PROJECT MAUI - ONCOLOGY

WARRINGAH ROAD & WAKEHURST PARKWAY, FRENCHS FOREST

SCHEDULE OF CHANGES	DEVELOPMENT APPLICATION Rev Revision Description Date
00. Change in layout and heights of	A Section 4.55 Update 23.06.202 B For Section 4.55 application 30.06.202
plant and mechanical overruns. External louvre screening updated to suit.

Maui - Healthcare Warringah Road & Wakehurst Parkway, Frenchs Forest, NSW Section 4.55 Modification

22. Bollards removed	Warri	ngah Road & Wakehur	
	23. Planter bed height, balustrade length increased	Parkv	•	
	24. Window height reduced by 200mm 25. Height reduced		R PLAN - GROUND

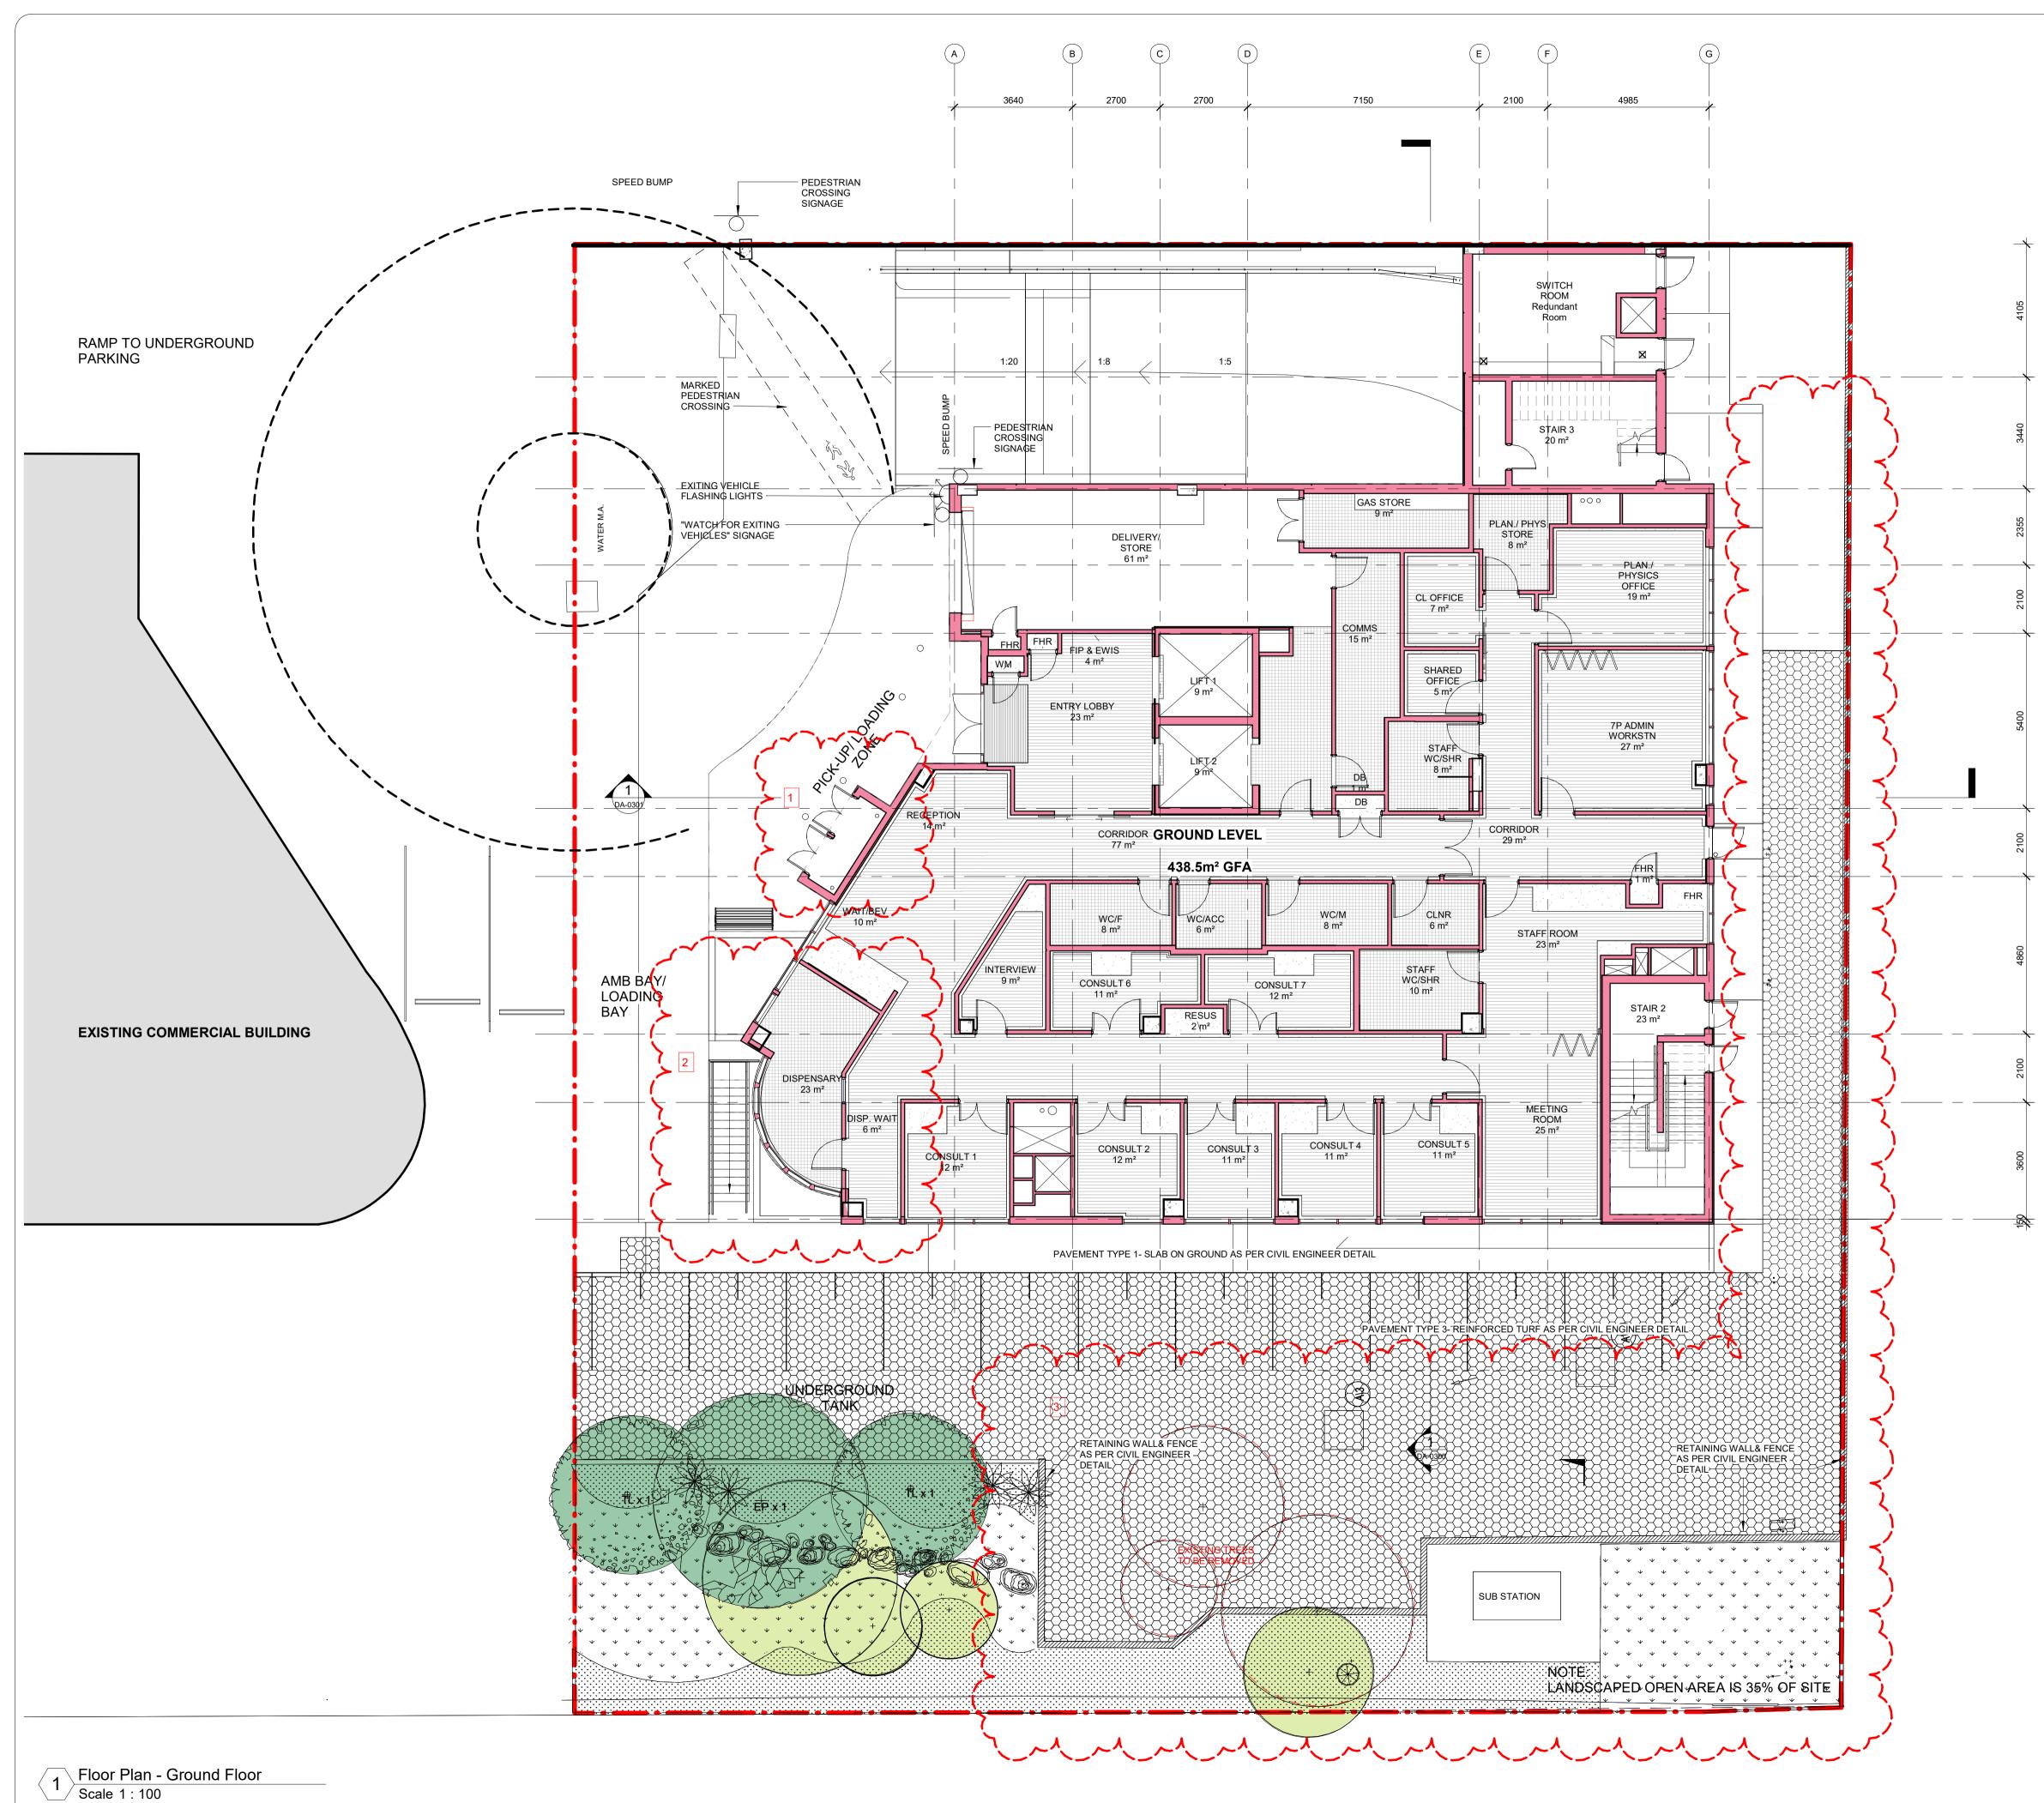
E.	EXISTING PLANTING	
3		E.	PROPOSED PLANTING	
				N AREA
5				
U				
7				
(8)				
0				
	SCHEDULE OF CHANGES			
9	00. Change in layout and heights of plant and mechanical overruns. External		OTE: EASEMENTS SUBJE	CT TO
	louvre screening updated to suit. 1. Hydrant booster reocated

2. Stair and glazing shifted inwards	_{Client} Gene	sisCare	
	 Landscaping updated Row of panels added 		3 Bourke Rd ria, NSW 2015	
	5. Louvre size updated6. Window shifted to accomodate			
	columns

7. Levels updated 8.Service penetrations added	<u>Client</u> Fores	t Central Business Par	k
	9. Sprinkler control valve, booster assembly and hydrant booster assembly	Construe	ction 9 PtyLtd ACN: 613 108 795 randview St, Pymble, NSW 2073	
	moved.

10. Height lowered by 360mm 11. Changed from curved glazing to		(-+)	
	polygonal 12. Louvre removed		0 1 2 3 4	5
	13. Balustrade deleted		SCALE	
	14. Width reduced 15. Increased by 25mm

16. Change to layout and height of			
	overuns. 17. Louvres extended	AF	RCHITE	CTS
	18. Window size reduced 19. Glazing and Louvre layout and sizes	SYDNEY Lvl 1/45 C	handos Street, Suite 204/9-11	MELBOURNE 1 Claremont Street, th Yarra VIC 3141
	updated	T: + 61 2	9437 3166 eam2.com.au ABN	N: 72 104 833 507 Reg Vic: 19340
	20 Louvres deleted, glazing reduced 21. Reduced from 150 before	Project:	ct Maui, Frenches Fore

26. Height increased by 200	Project #: 856		SG VM
	27. Finishes updated	<u>Drawing #:</u>	DA-0103	B

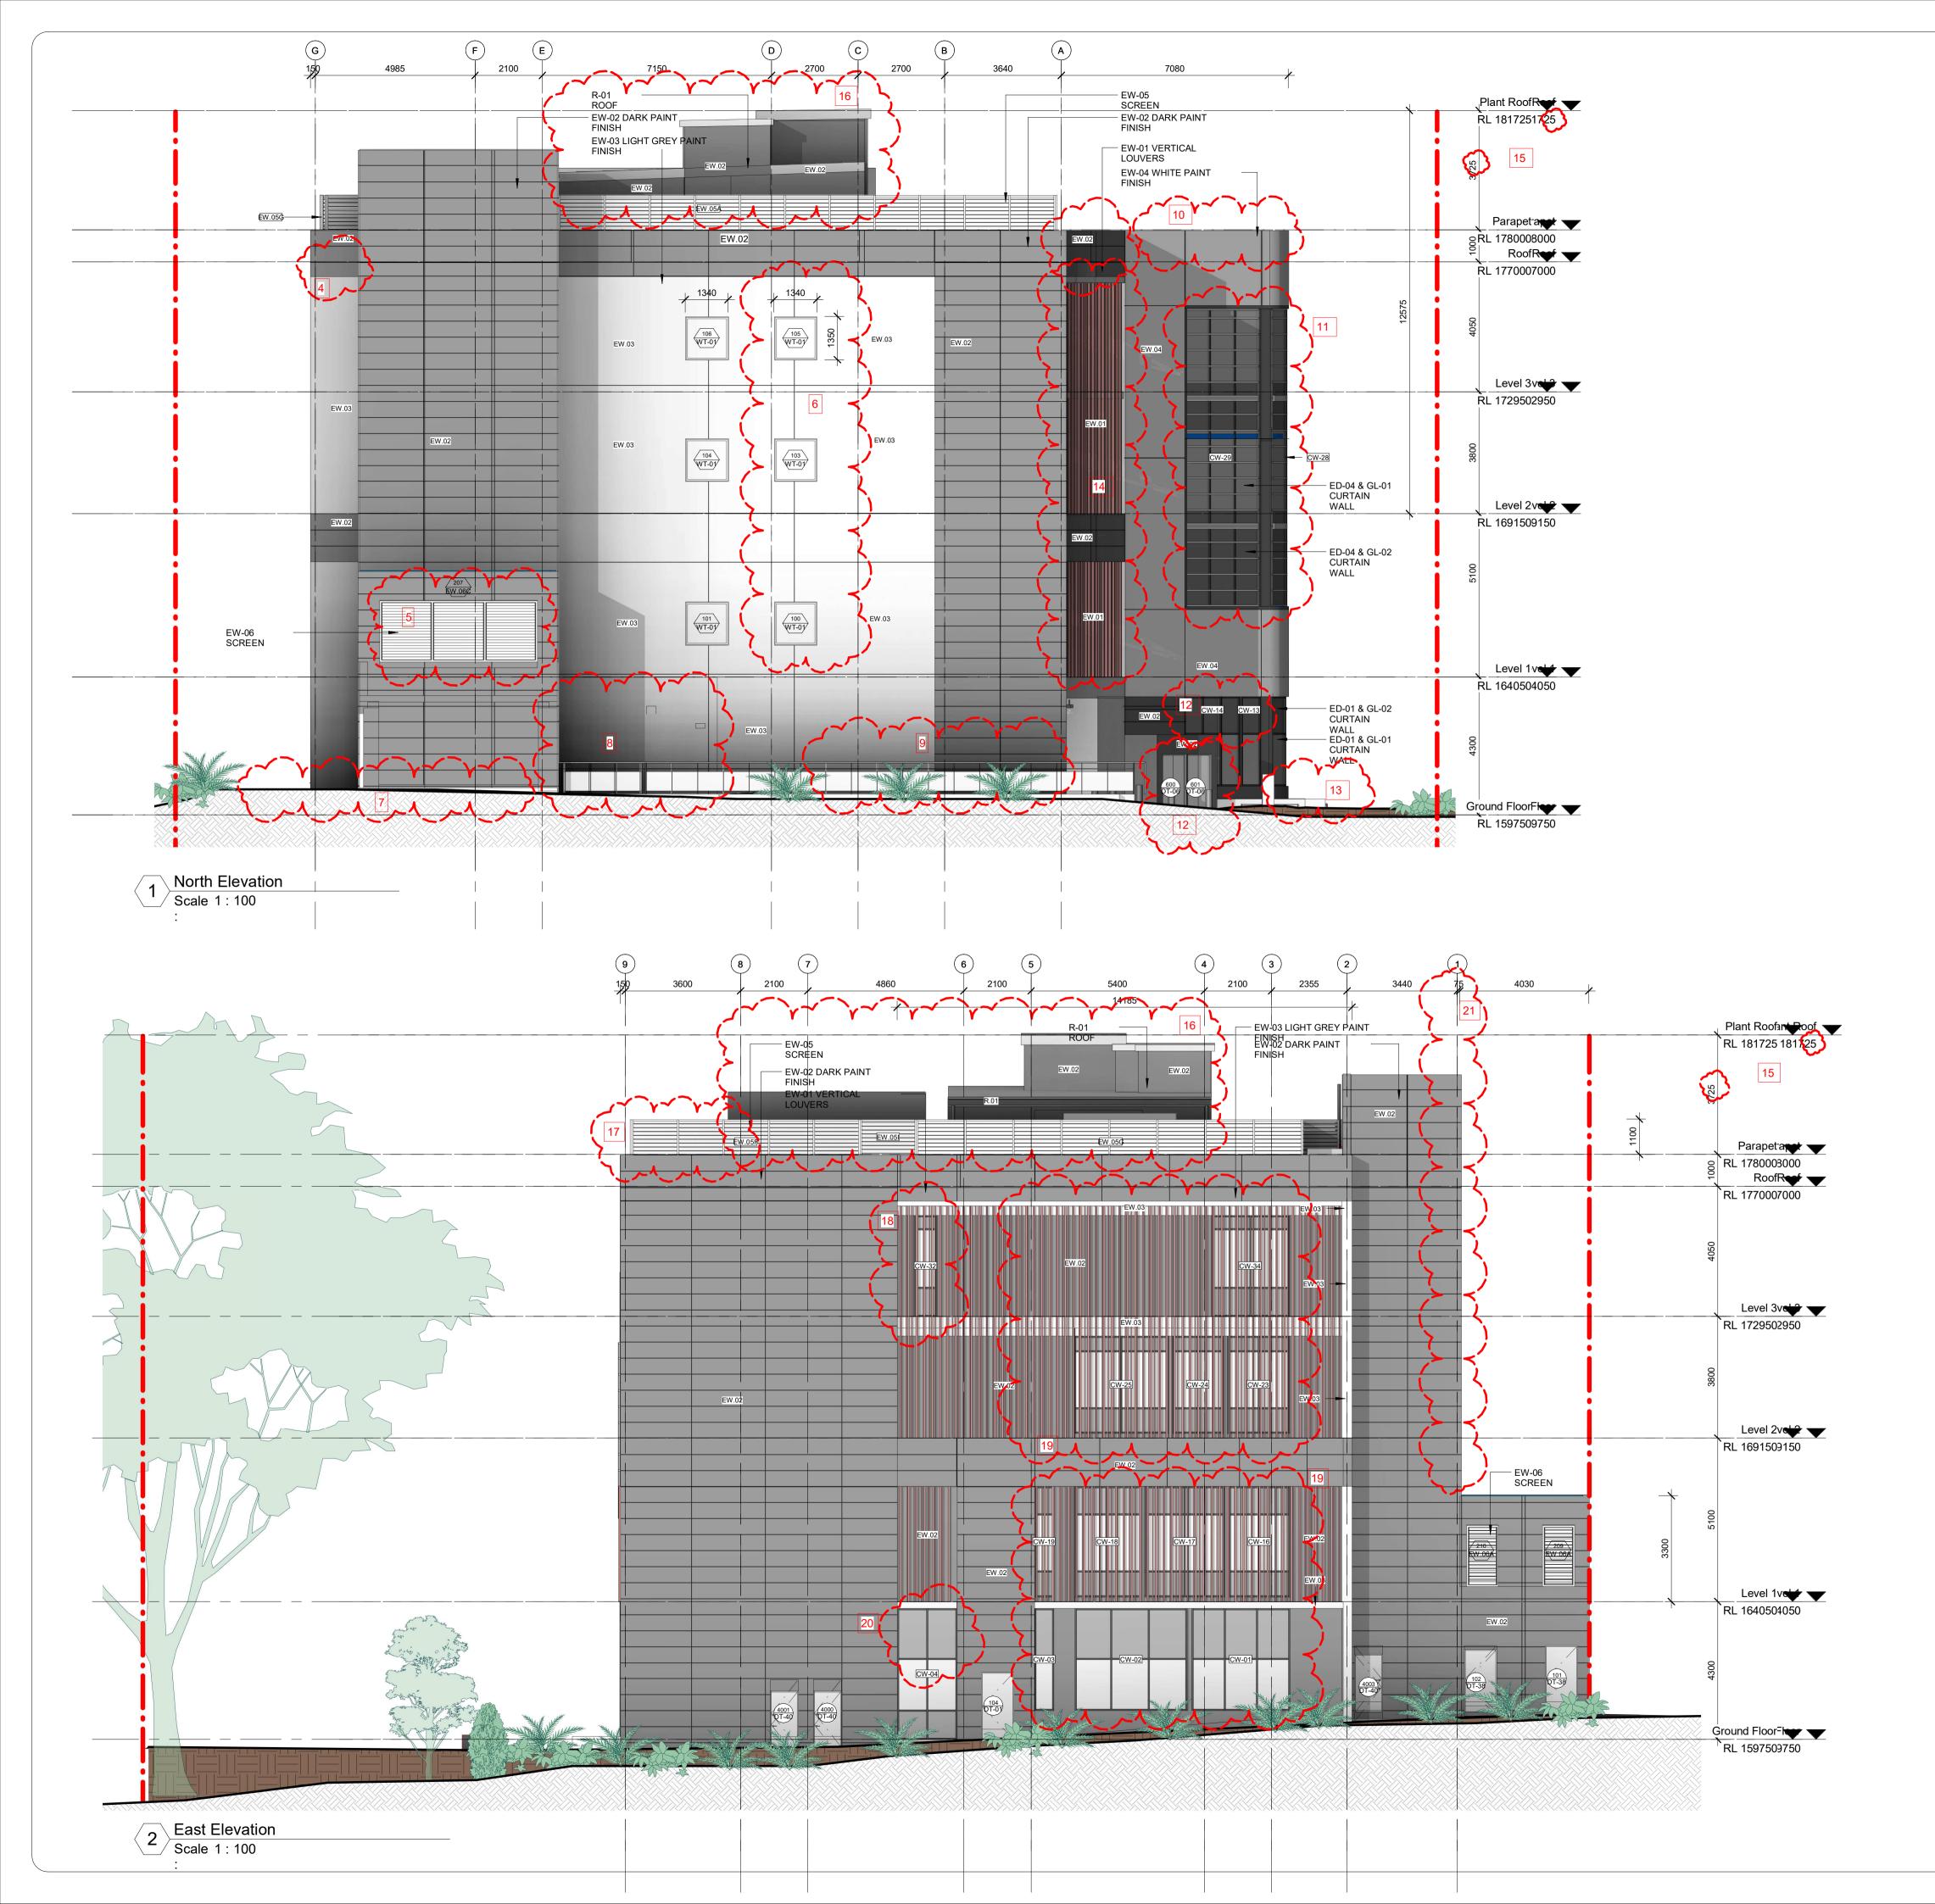
Service penetrations added	person as a	DRAWING	rposes.
Sprinkler control valve, booster ssembly and hydrant booster assembly		LEGEND: ural drawings shall be read in conjunction with other or ns. Any discrepancies shall be referred to Team 2 Arc	
oved.	proceeding 2. All dimen	with work. sions and levels are in millimeters unless noted otherw	
). Height lowered by 360mm	3. All dimen Architects b	by scaling the drawing. sions to be checked on site with any discrepancies ref before proceeding with work.

1. Changed from curved glazing to		to be carried out in accordance with the requirements of urrent NCC & Australian standards.	of the principal certifying
olygonal 2. Louvre removed		EASEMENTS INDICATIVE, TBC AS CI	JRRENTLY

3. Balustrade deleted		R REVIEW	
4. Width reduced			
5. Increased by 25mm 6. Change to layout and height of			
veruns.			
7. Louvres extended			
 B. Window size reduced B. Glazing and Louvre layout and sizes 			
dated			
) Louvres deleted, glazing reduced			
. Reduced from 150 before . Bollards removed			
. Planter bed height, balustrade length			
creased			
. Window height reduced by 200mm

6. Height increased by 200			
7. Finishes updated			
	Client		
		sisCare	
		3 Bourke Rd Iria, NSW 2015	
	Client		
	Fores	st Central Business Par	k
		ction 9 PtyLtd ACN: 613 108 795 irandview St, Pymble, NSW 2073	
	1
